SUBJECT: SURRY POWER STATION, UNIT NOS. 1 AND 2 - STAFF ASSESSMENT OF INFORMATION PROVIDED PURSUANT TO TITLE 10 OF THE *CODE OF FEDERAL REGULATIONS* PART 50, SECTION 50.54(f), SEISMIC HAZARD REEVALUATIONS FOR RECOMMENDATION 2.1 OF THE NEAR-TERM TASK FORCE (NTTF) REVIEW OF INSIGHTS FROM THE FUKUSHIMA DAI-ICHI ACCIDENT AND STAFF CLOSURE OF ACTIVITIES ASSOCIATED WITH NTTF RECOMMENDATION 2.1, "SEISMIC" (TAC NOS. MF3953 AND MF3954)

STAFF ASSESSMENT BY THE OFFICE OF NUCLEAR REACTOR REGULATION

RELATED TO SEISMIC HAZARD AND SCREENING REPORT

SURRY POWER STATION, UNITS 1 AND 2

Figure 3.3-1: Plot of Staff's and Licensee's Base Case Shear-Wave Velocity Profiles for the SPS site

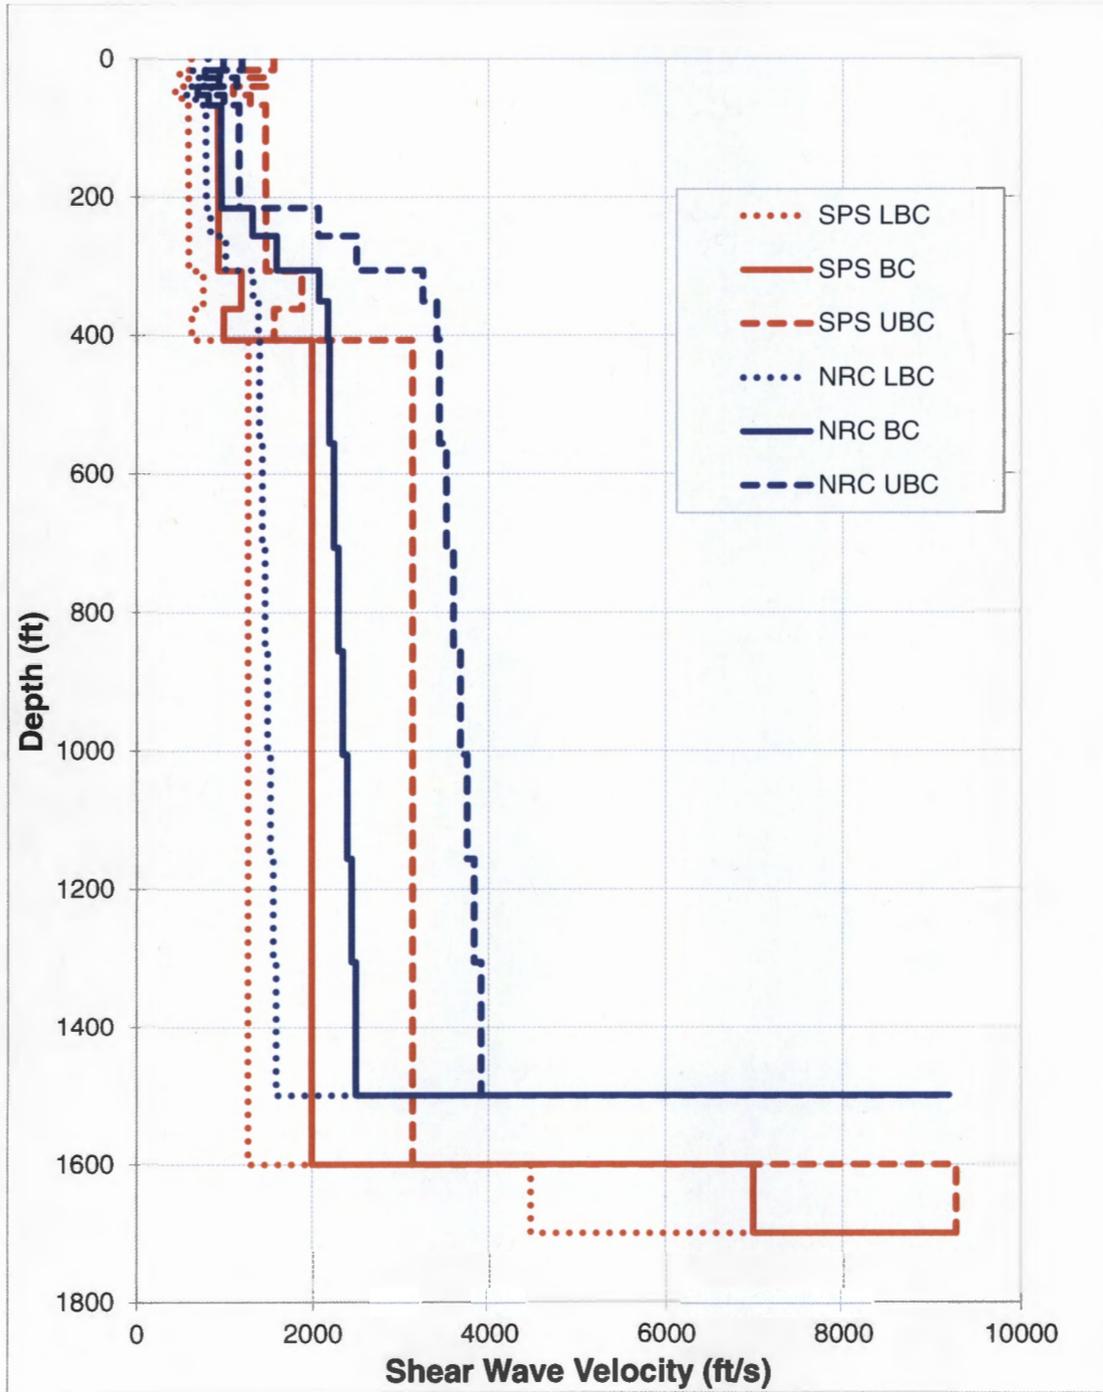
To estimate the shear wave velocities for its best estimate or middle base case profile for the upper 140 ft. [42.7 m], the licensee used the blow count values from Standard Penetration Testing. For the deeper soil layers to a depth of 1600 ft. [488 m], the licensee estimated the shear wave velocities based on the soil type and its depth beneath the site. Finally, for the metamorphic rock between 1600 ft. [488 m] and 1700 ft. [518 m], the licensee assumed a shear wave velocity of 7000 feet per second (fps) [2130 meters per second (m/s)]. At a depth of 1700 ft. [518 m], the licensee assumed the reference or base rock shear wave velocity of 9200 fps [2800 m/s]. Due to the large uncertainty in the shear wave velocity estimates for the best estimate base case profile, the licensee calculated lower and upper base case profiles using a scale factor of 1.57, reflecting a natural log standard deviation of 0.35. Table 2.3.1-2 and Figure 2.3.2-1 of the SHSR provide the licensee's shear-wave velocity profile for each of the three

base cases. Figure 3.3-1 of this assessment shows the licensee's three shear-wave velocity base case profiles.

To develop its best estimate base case velocity profile over the upper 200 ft. [61 m], the NRC staff assumed the same values as the licensee. Below 200 ft. [61 m], the NRC staff assumed a constant velocity gradient down to the base of the profile at a depth of 1,500 ft (457 m). To capture the uncertainty in the shear wave velocities, the NRC staff used a scale factor of 1.21 to calculate upper and lower base case velocity profiles, which is consistent with a natural log standard deviation of 0.15. Figure 3.3-1 of this assessment shows a comparison of the three velocity profiles developed by the licensee with those developed by the NRC staff. The profiles developed by the NRC staff are similar to those developed by the licensee, but have higher velocities at depths greater than 200 ft (61 m). In addition, the NRC staff assumed a somewhat shallower depth to metamorphic rock beneath the site and that the shear wave velocity for this rock is the reference rock value of 9200 fps (2800 m/s). The NRC staff randomized the depth to reference rock by  $\pm 300$  ft (91 m) to allow for additional uncertainty.

Figure 3.3-2 Plot Comparing the Staff's and the License's Median Amplification Functions and Uncertainties for two input loading levels for the SPS site

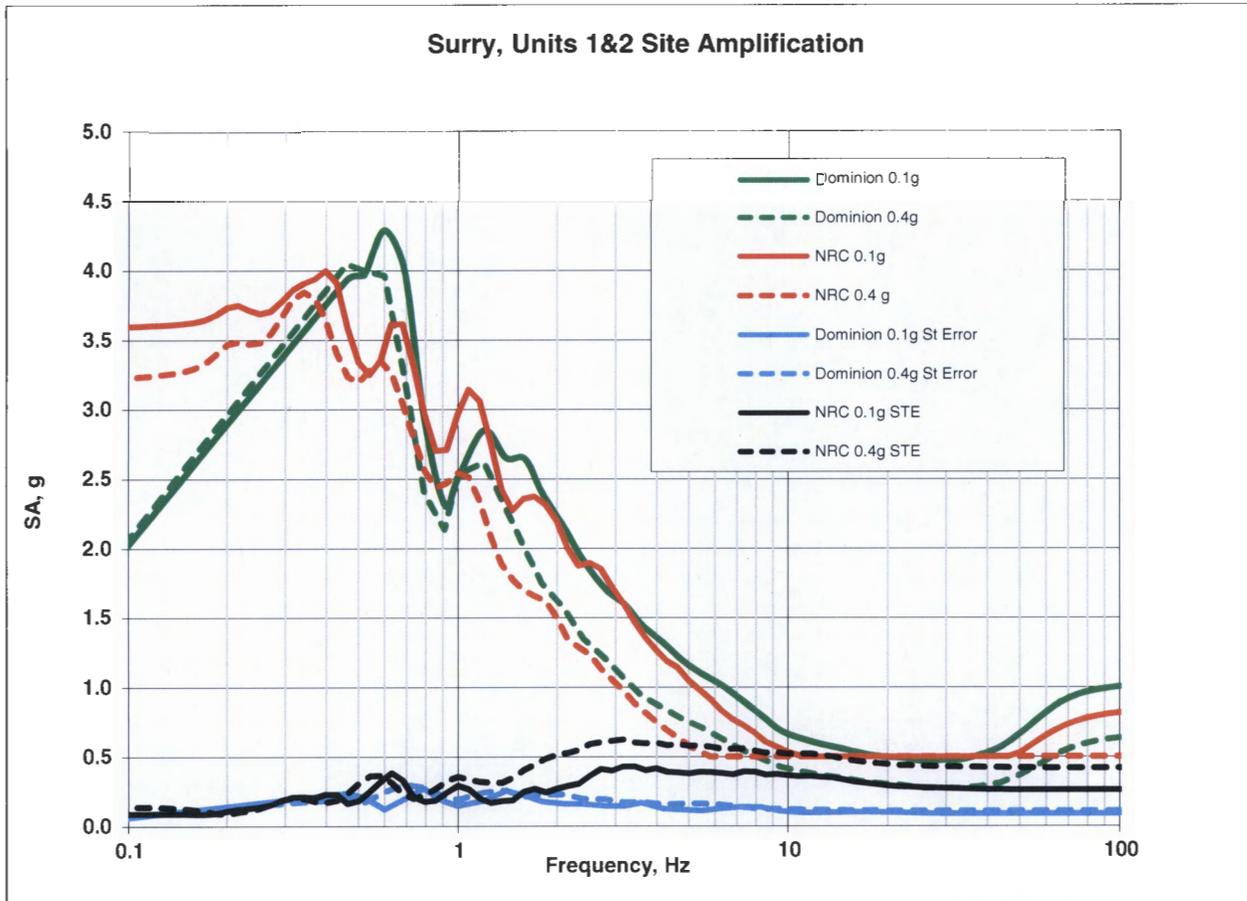
Figure 3.3-2 of this assessment shows a comparison of the staff's and licensee's median site amplification factors and uncertainties ( $\pm 1$  standard deviation) for 2 of the 11 input loading levels. The staff's median site amplification factors are similar to the licensee's amplification factors. In addition, the staff's and licensee's uncertainties are similar at frequencies below 2 Hz. At higher frequencies the staff's uncertainties are slightly higher than the licensee's.

Figure 3.3-3 Plot Comparing the Staff's and the Licensee's Mean Control Point Hazard Curves at a Variety of Frequencies for the SPS site

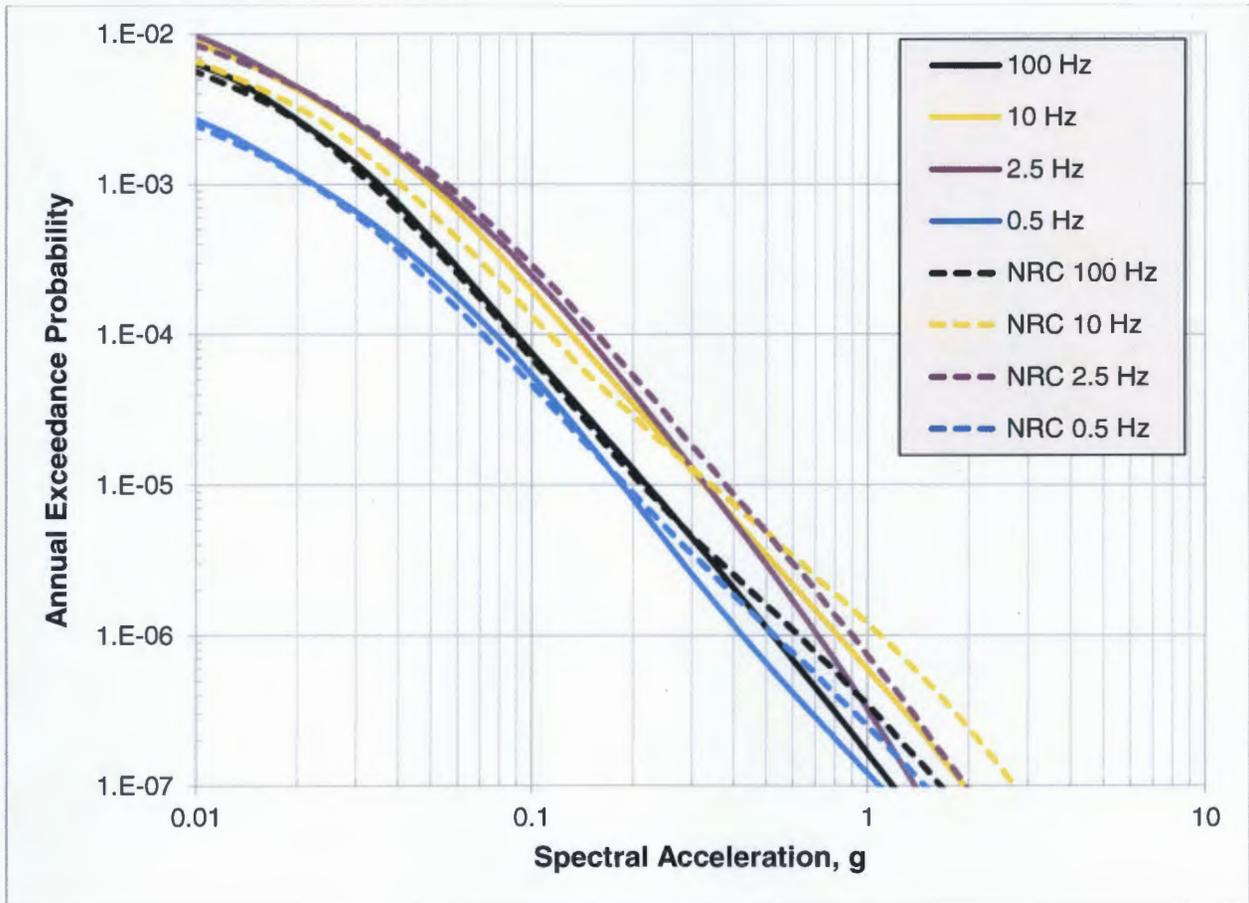
The licensee's approach to modeling the subsurface rock properties and their uncertainty results in similar site amplification factors. As shown in Figure 3.3-3, the control point seismic hazard curves developed by the licensee and NRC staff are also similar. Appendix B of the SPID provides guidance for performing site response analyses, including capturing the uncertainty for sites with less subsurface data. As such, alternative approaches in performing site response analyses, including the modeling of uncertainty, are acceptable for the 50.54(f) response.

Figure 3.4-1 Comparison of the Staff's GMRS, Licensee's GMRS, and the SSE for the SPS site

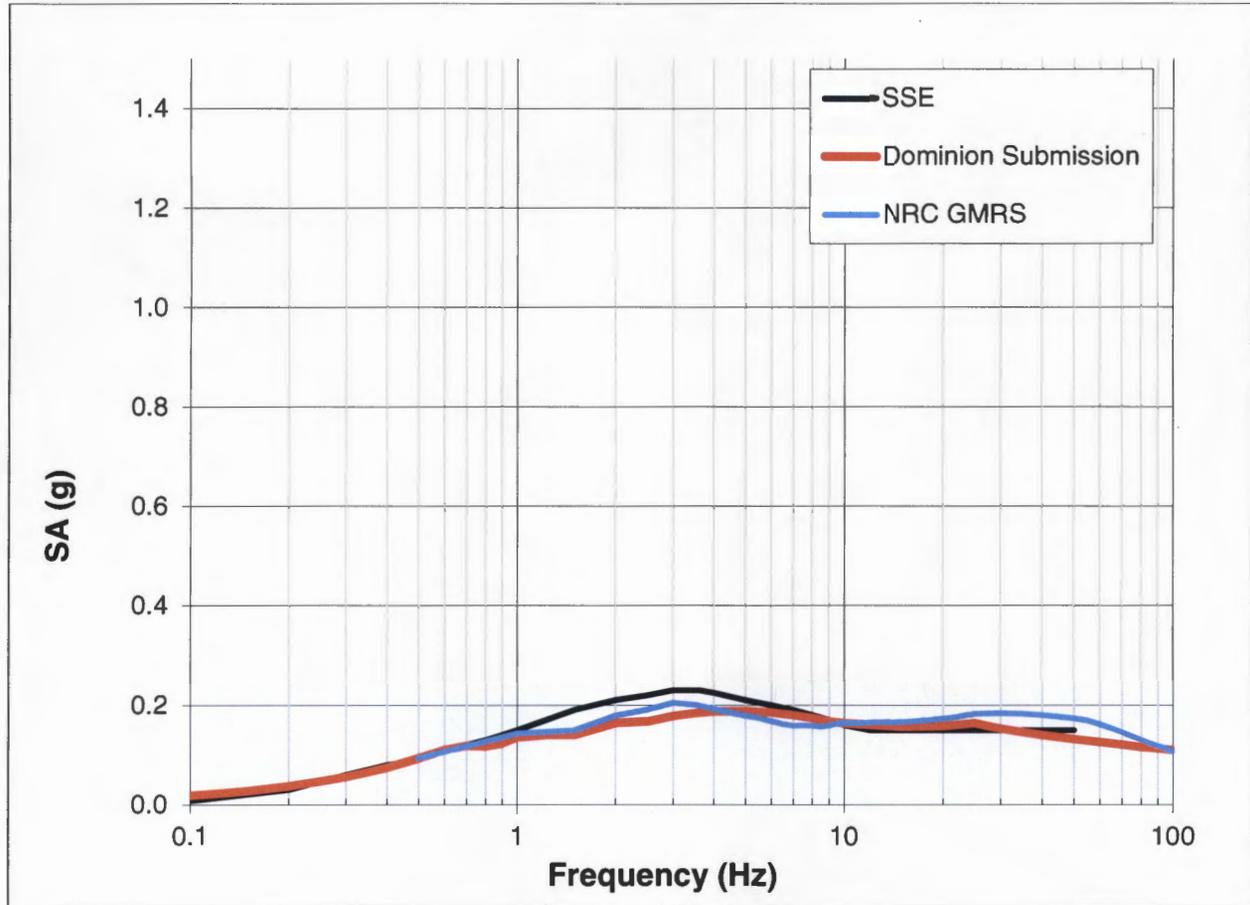
The NRC staff independently calculated the  $10^{-4}$  and  $10^{-5}$  UHRS using the results of its confirmatory PSHA and site response analyses, as described in Sections 3.2 and 3.3 of this staff assessment, respectively. Figure 3.4-1 of this assessment shows a comparison of the GMRS determined by the licensee to that determined by the NRC staff.

As shown in Figure 3.4-1 below, the licensee's GMRS shape is similar to that calculated by the NRC staff at frequencies less than 10 Hz. However, the staff's confirmatory GMRS is somewhat higher than the licensee's at frequencies above 10 Hz. As described above in Section 3.3, the NRC staff concludes that these minor differences over the higher frequency range are primarily due to the differences in the site response analyses performed by the licensee and NRC staff.

The NRC staff confirms that the licensee used the present-day guidance and methodology outlined in RG 1.208 and the SPID to calculate the horizontal GMRS, as requested in the 50.54(f) letter. The NRC staff performed both a PSHA and site response confirmatory analysis and achieved results consistent with the licensee's horizontal GMRS. As such, the NRC staff concludes that the GMRS determined by the licensee adequately characterizes the reevaluated hazard for the Surry site. Therefore, this GMRS is suitable for use in subsequent evaluations and confirmations, as needed, for the response to the 50.54(f) letter.
